Hayes Park

Planning Responses

21.11.23

DOCUMENT CONTROL	
JOB TITLE	Hayes Park
JOB NUMBER	0419
REPORT TITLE	Planning Response 2
REVISION	P1
DATE OF ISSUE	20.11.23
PURPOSE OF ISSUE	For Planning
COMPILED BY	STUDIO EGRET WEST
REVIEWED BY	GN
DATE REVIEWED	21.11.23

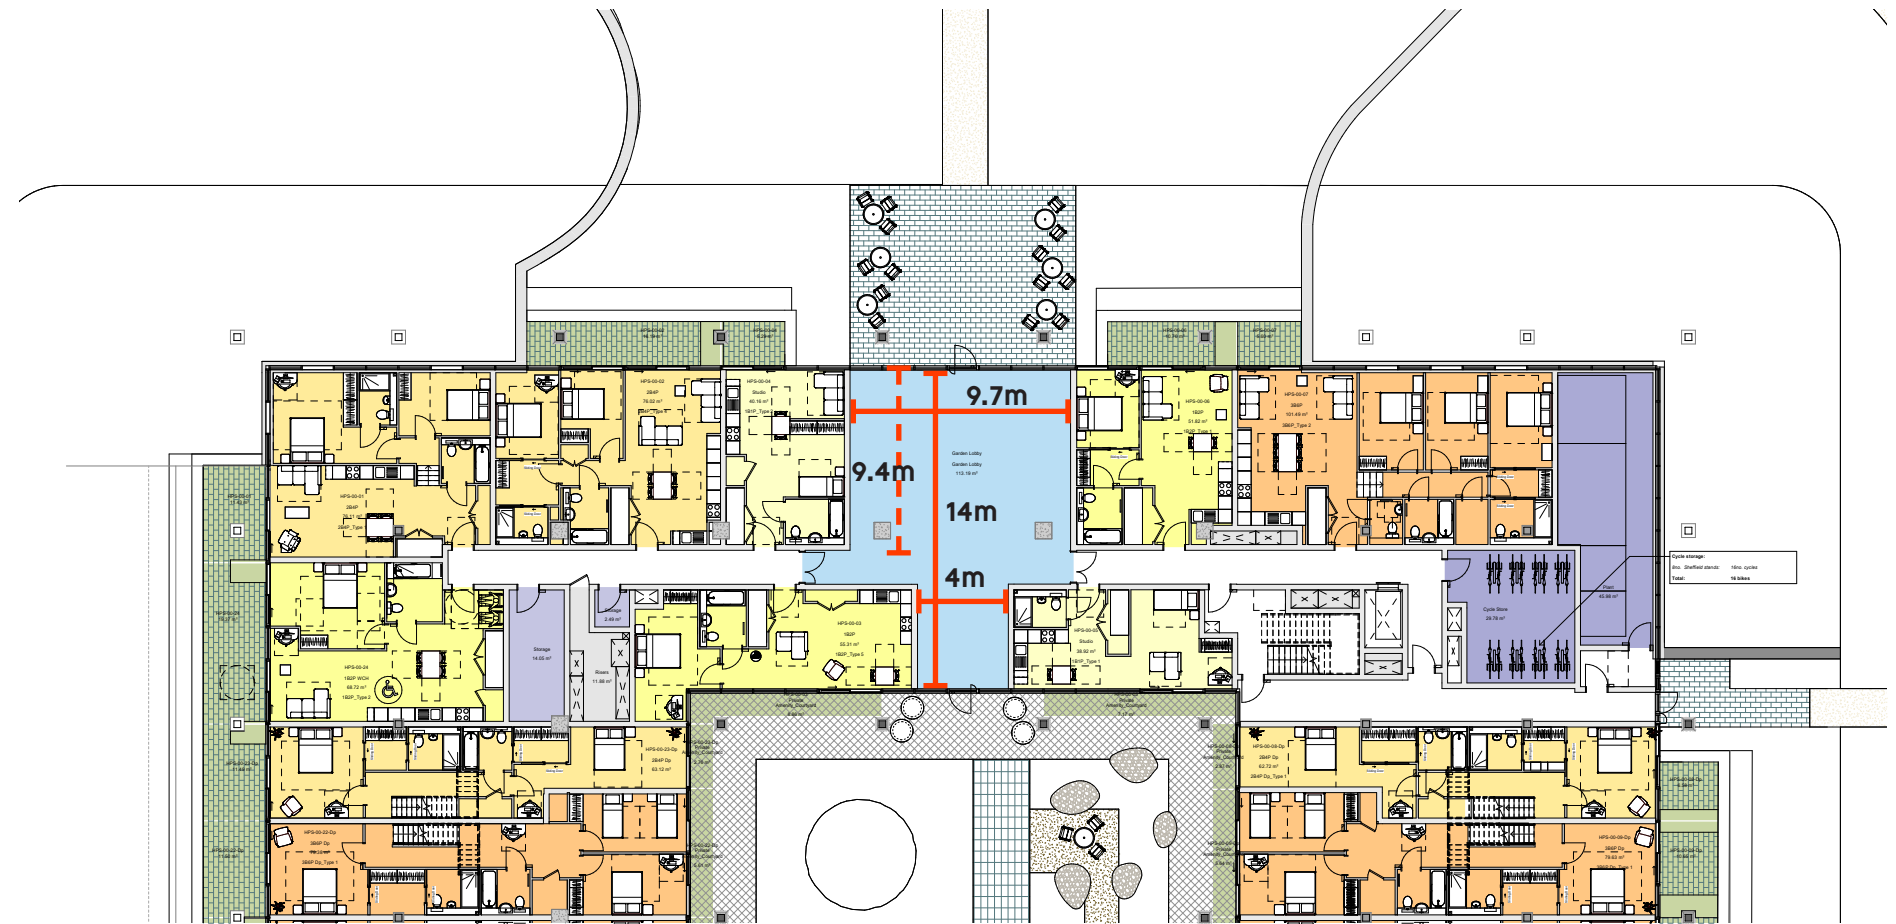
Firstly, the limited communal space which opens out around two piers but is not the full width of the bays. This fails to deliver on this potential heritage gain to mitigate the harm. This issue was raised during the pre-app process. The effect of looking through from front to back is effectively restricted to a narrow corridor.

The drawings currently propose a 4m wide route into the central courtyard. This is almost three times the width of a typical residential corridor so offers significant generosity compared to typical circulation.

Partitions are set out to align with the existing curtain wall mullion locations. In order to increase the width of this space and ensure symmetry with the elevation and courtyard, the route would need to be widened by an additional two bays, totalling 2.8m.

The resulting space would be 7m wide, 14m long and 3.5m tall - comfortably fitting two single decker buses or a full sized badminton court within it. As a residential lobby this would feel oversized for the function and number of homes served.

Hayes Park South - Sketch to show the scale of space in the Western lobby looking out towards the park

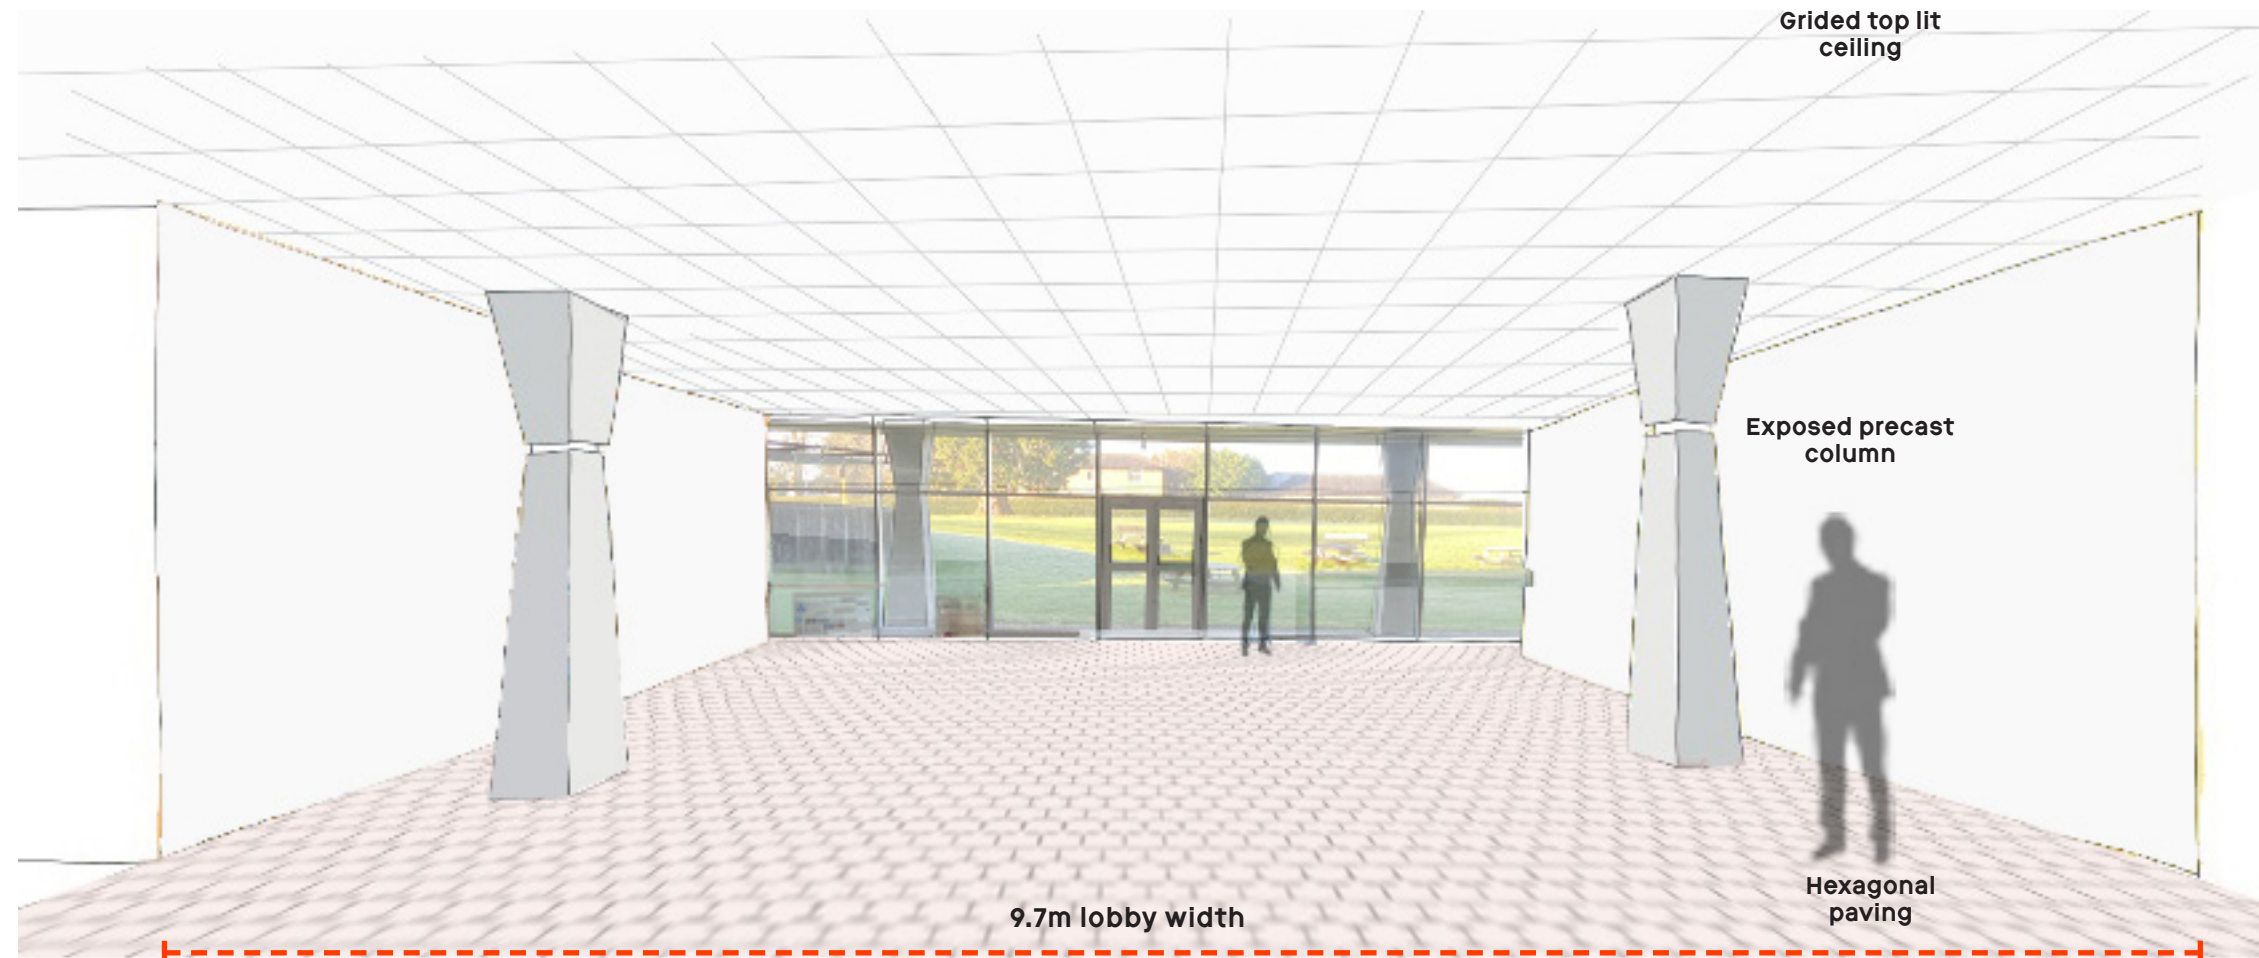
'The previous conservation comments related to the Canteen area are retained.

The preceding images depict the protected vistas from the courtyard overlooking the park and the internal perspective from the park towards the building.

From the courtyard angle, the park's grassland is visible, and enhancing visibility involves clearing the canteen clutter in the foreground of the image.

The park view, however, lacks a clear visual connection to the courtyard. Improving this link entails de cluttering and adjusting the lighting to enhance connectivity.

The adjacent sketch illustrates an interior view of the lobby facing the parkland. The space is notably expansive, offering residents a generous view of the park.

This lobby aims to be a welcoming area, affording residents an impressive view both into and through the building. Seven large window modules on the park side ensure ample natural light.

While smaller than the original canteen, this redesigned space effectively preserves critical views through the building, suitably sized for its new purpose.

Hayes Park South - potential location of privacy film

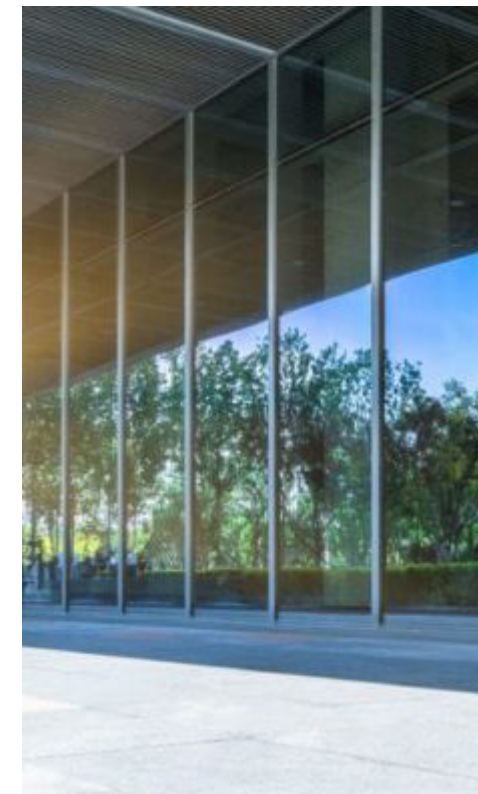
There are four single aspect units on the ground floor of each corner of the reflective pool. These suffer from limited outlook, sub-optimal daylight/sunlight and privacy issues with residents provided with seating within the north side of the reflective pool. The proposed indicative planters (shown on drawing SEW 0419-SEW-HS-00-DR-A-253225) to mitigate privacy issues would create visual clutter that lacks design coherence with the Japanese garden design and open area of the reflective pool.

As previously stated, it would be preferable to reinstate the entirety of the pool, removing the seating that would likely create privacy issues for the residents of the ground floor units to improve the accommodation standard, particularly of the four corner units around the courtyard, which suffer other liveability compromises.

While the homes situated at the corners offer a view of the courtyard, some potential for overlooking exists. To ensure privacy, the layout has been intricately planned, strategically situating the bedroom areas in the corners of each unit. In order to improve privacy a privacy film can be added on the inside corner windows, providing a temporary tinted effect akin to greyish tinted glazing of the existing. The diagram at the top of this page identifies the windows suitable for the application of this film.

Moreover, additional movable planters could be thoughtfully placed to offer additional screening for the homes positioned behind.

Hayes Park Updated Building Interface Sections

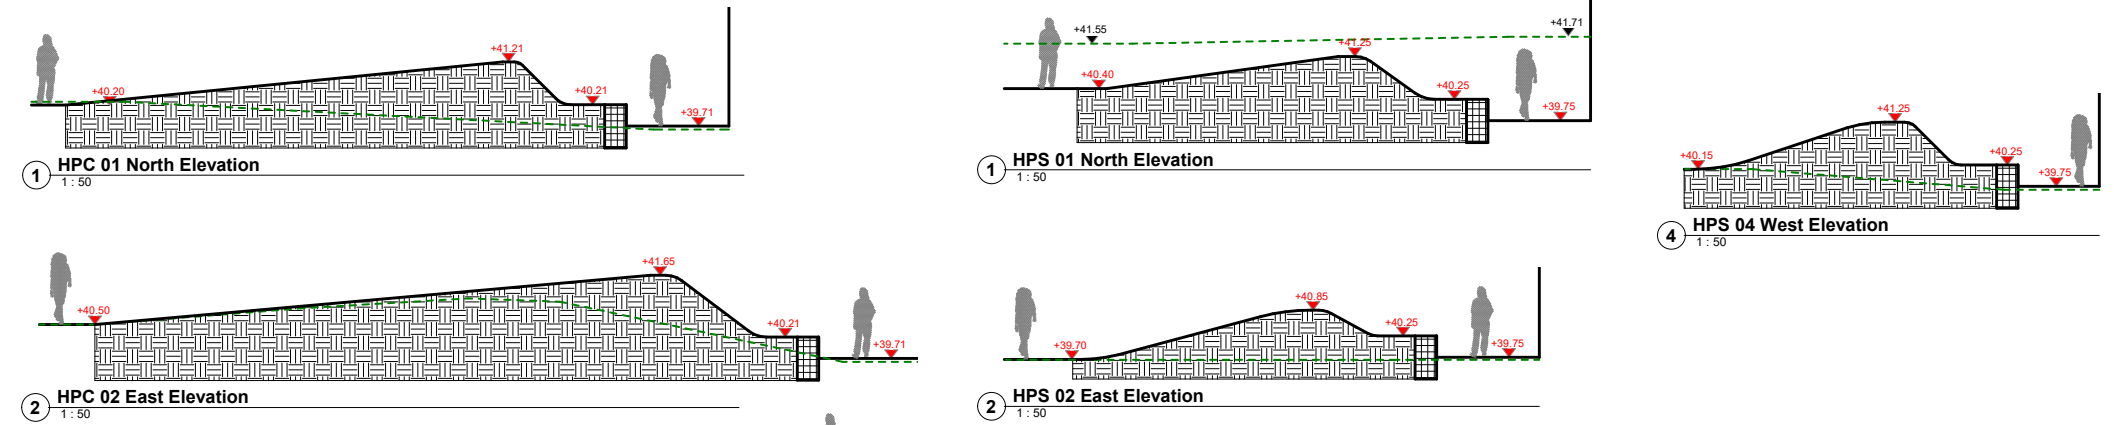
The principle of mounding is accepted. However, it is considered that in some instances the mounding should be better integrated into the existing levels with a gentler slope, to ensure it is almost visually imperceptible. It is considered that, Hayes Park Central north, east elevations and Hayes Park South north, east and west elevations particularly need to be revised to look less engineered.

Clarification is sought on where the additional soil will be imported from.

We acknowledge the comments raised and have amended the elevations on sheets '0419-SEW-ZZ-00-DR-L-001005' and '0419-SEW-ZZ-00-DR-L-001006'.

Additional soil will be sourced from excavating existing ground from HPC south elevation, HPS south elevation, and the sunken play space. Should additional soil be required, imported soil shall be specified and tested in accordance with BS3882:2015.

Hayes Park Garden Square Proposals
Balance of planting and hard standing for residents to enjoy

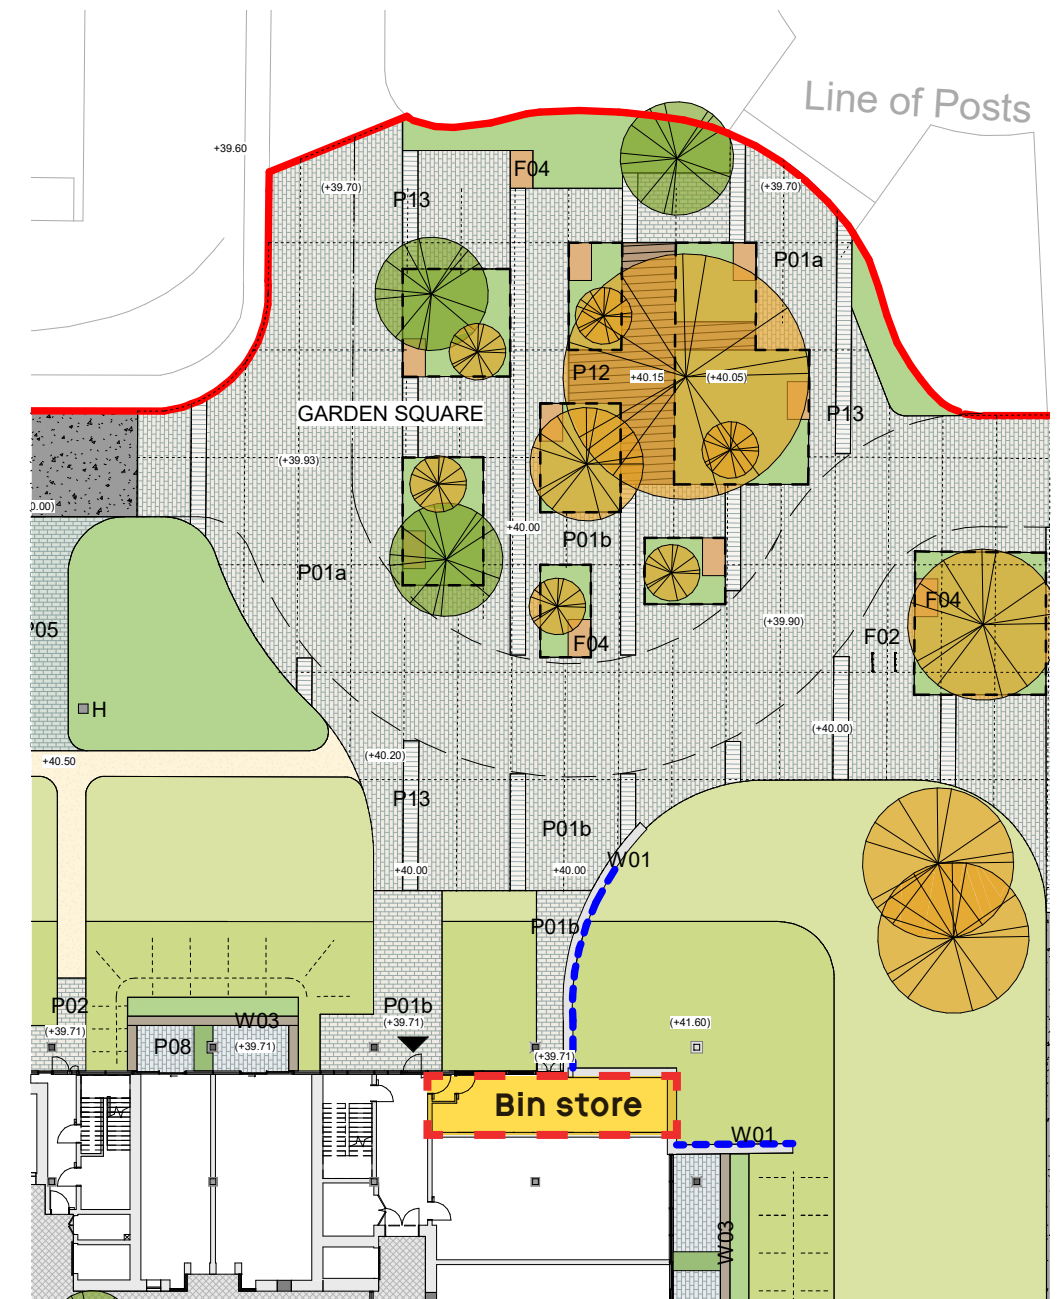
While the updates are looking less urban, the proposed area of hardstanding is still considered to be too extensive. Reducing the hard-surfacing would reduce costs. Clarification is sought that a bin store will no longer be located in this area.

The intention of the Garden Square is to create a space for residents to sit, dwell and socialise. A combination of retained shrubs and new ornamental planting provides a pleasant backdrop and garden space that is unique to the rest of Hayes Park.

The areas of hardstanding offers relief for residents to occupy a space that is sheltered from the shared vehicle route. Furthermore, the square has the potential to host events for the residents, thus allowing the rest of the landscape to retain its distinctive parkland character.

Reducing the hard standing could make the space less usable, and potentially reverts the design back to the existing condition as a round-about, as opposed to creating a pedestrian friendly environment.

The bin store to HPC is internalised and located on the north-east corner of the building. Access to the bin store will be limited to bin collection days.
